**THIRD RESPONSE TO REQUEST FOR ADDITIONAL INFORMATION
PERMIT TO OPERATE COMPOSTING FACILITY
PERMIT TO CONSTRUCT LEACHATE TREATMENT FACILITY
PERMIT TO OPERATE RESOURCE RECOVERY FACILITY
WASTE TIRE GENERAL PERMIT
AND
PERMIT TO MAINTAIN CLOSED CLASS I SANITARY LANDFILL
PREPARED FOR**

**BOARD OF COUNTY COMMISSIONERS
DEPARTMENT OF PUBLIC WORKS
222 EAST McCOLLUM AVENUE
BUSHNELL, FLORIDA 33513**

October 2, 1992

RE: SUMTER COUNTY SOLID WASTE FACILITIES
PERMIT NO.:

5

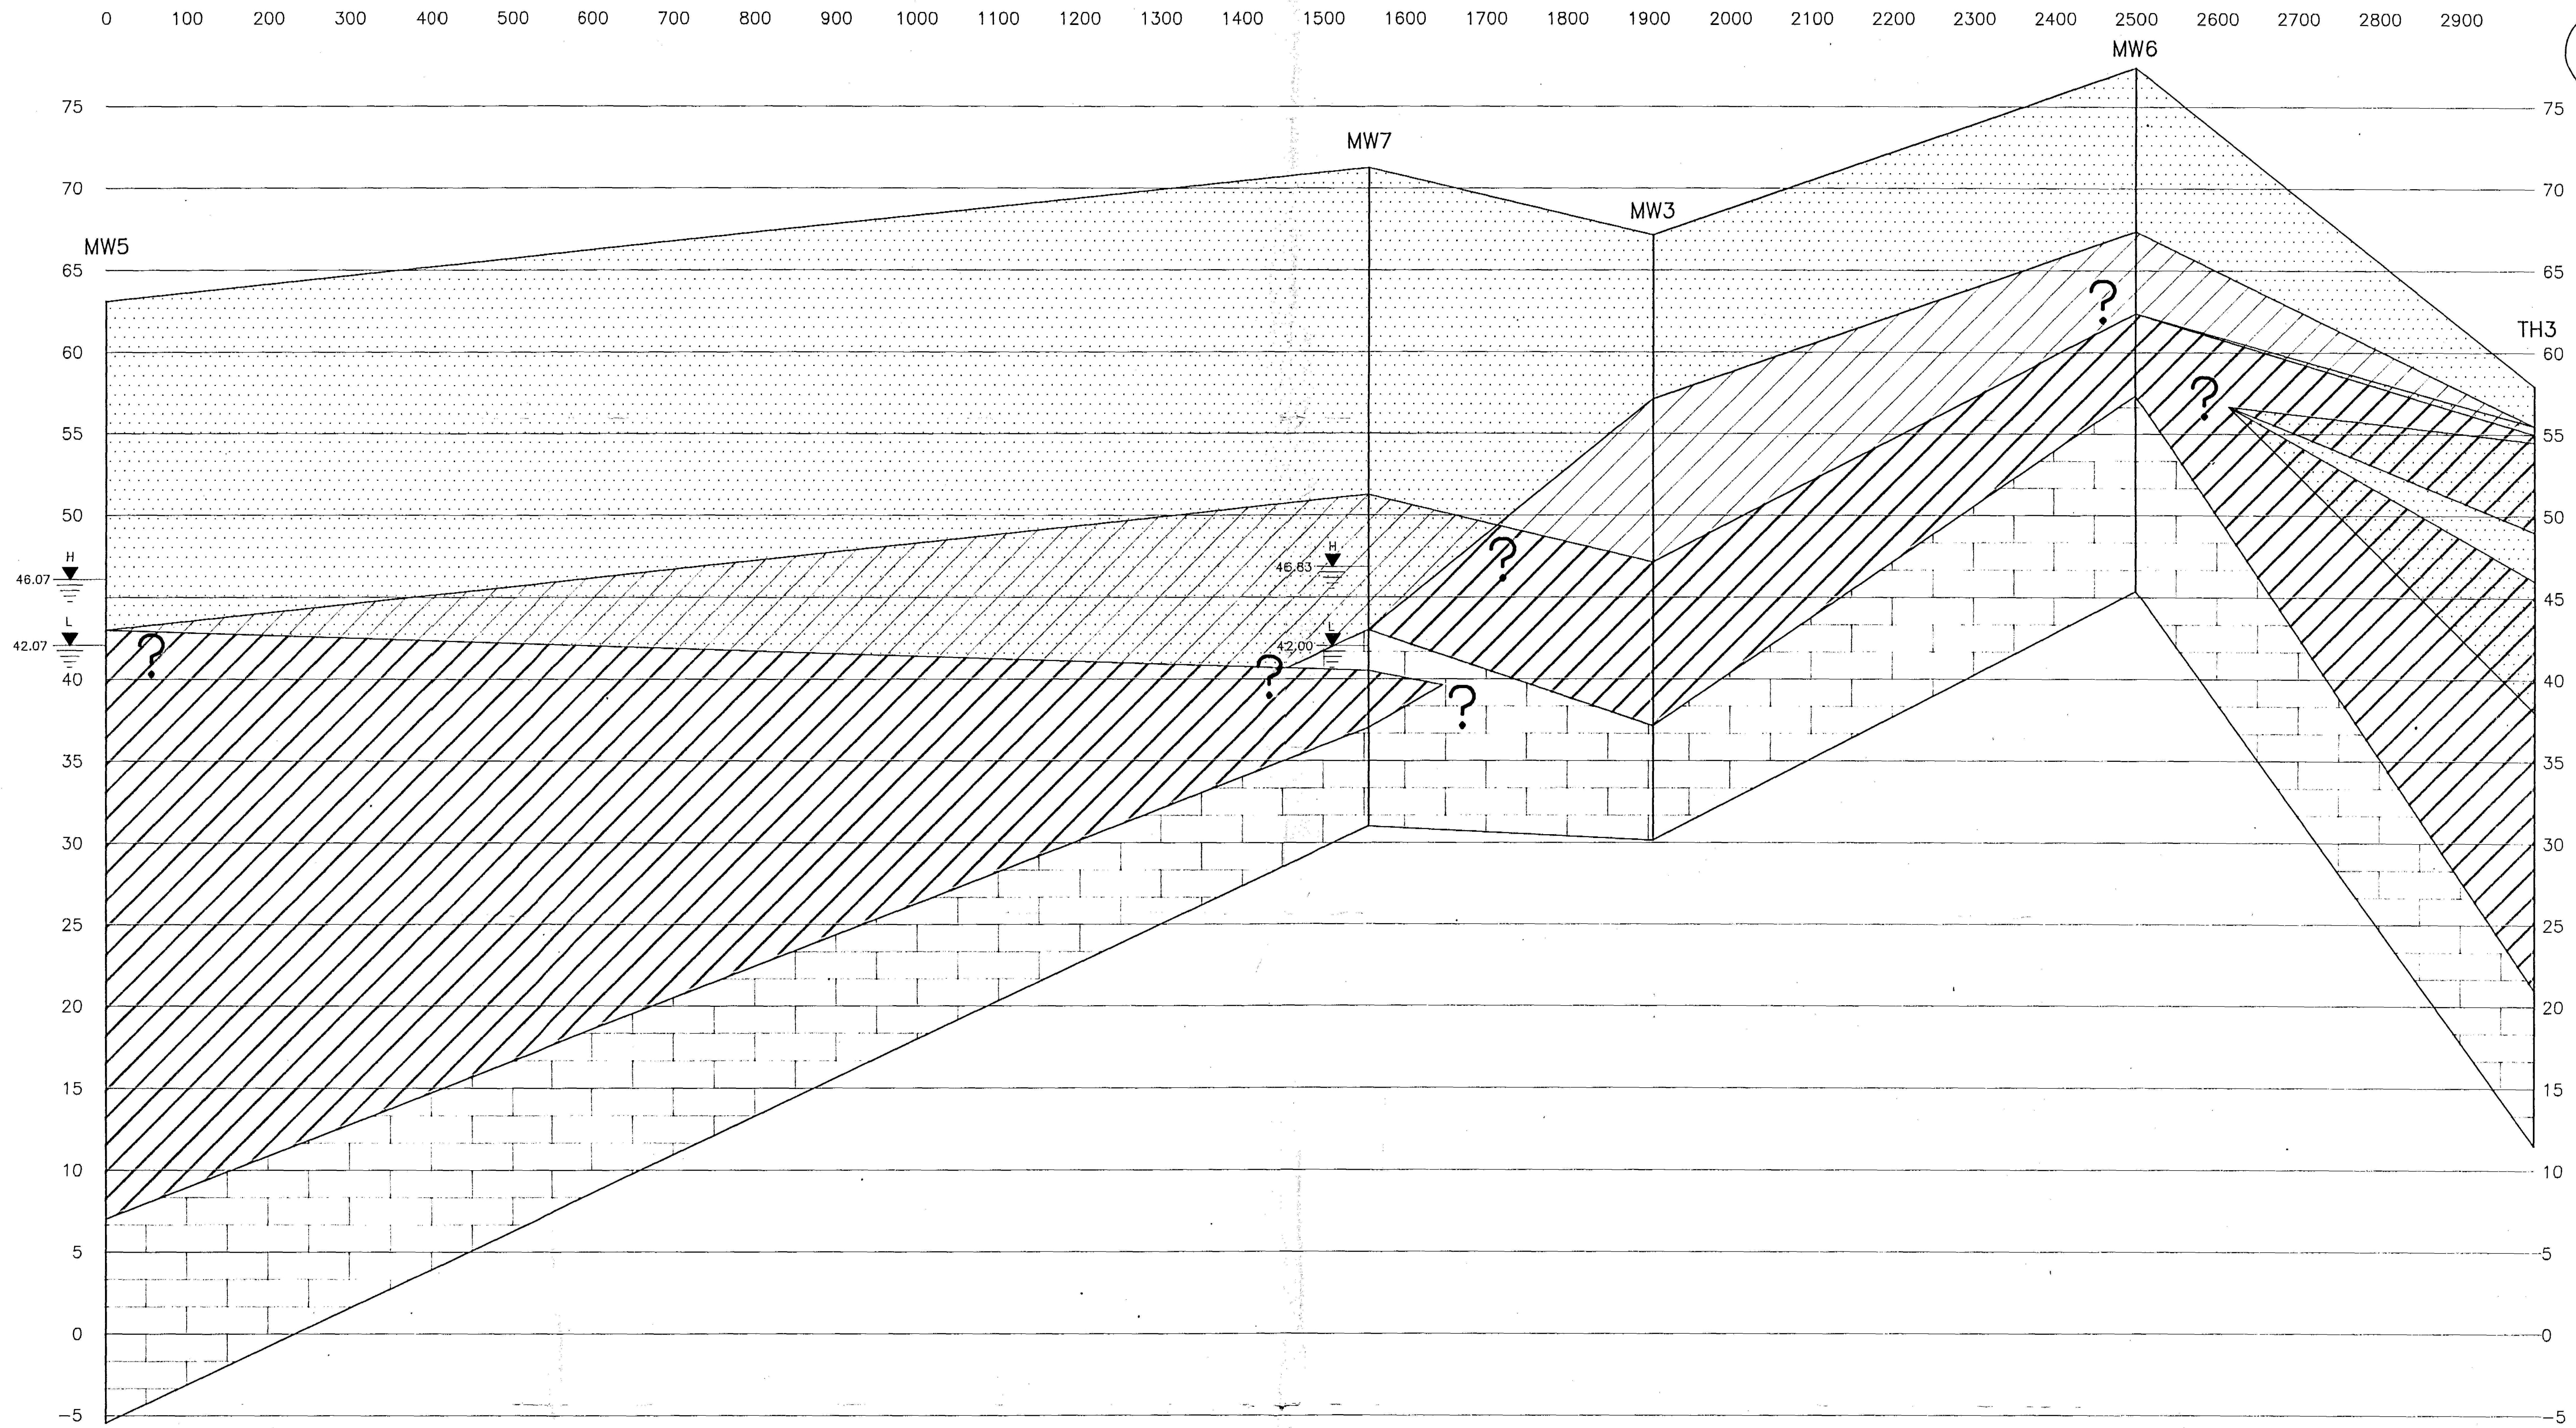
- 3.6. The water table should be illustrated on the cross-sections. The most recent seasonal high and low water table as measured from the monitor wells should be used.

- 3.5. General cross-sections have been prepared and are enclosed in Appendix C. The borings denoted by the "TH" prefix were performed by drillers specializing in foundation engineering. These logs contain more detailed information than the logs prepared from data obtained from the monitor well completion reports.

- 3.6. The highest and lowest groundwater elevations encountered during sampling events for the monitoring wells for the period beginning January 8, 1991 and ending April 7, 1992 are shown on the general cross-sections presented in Appendix C.
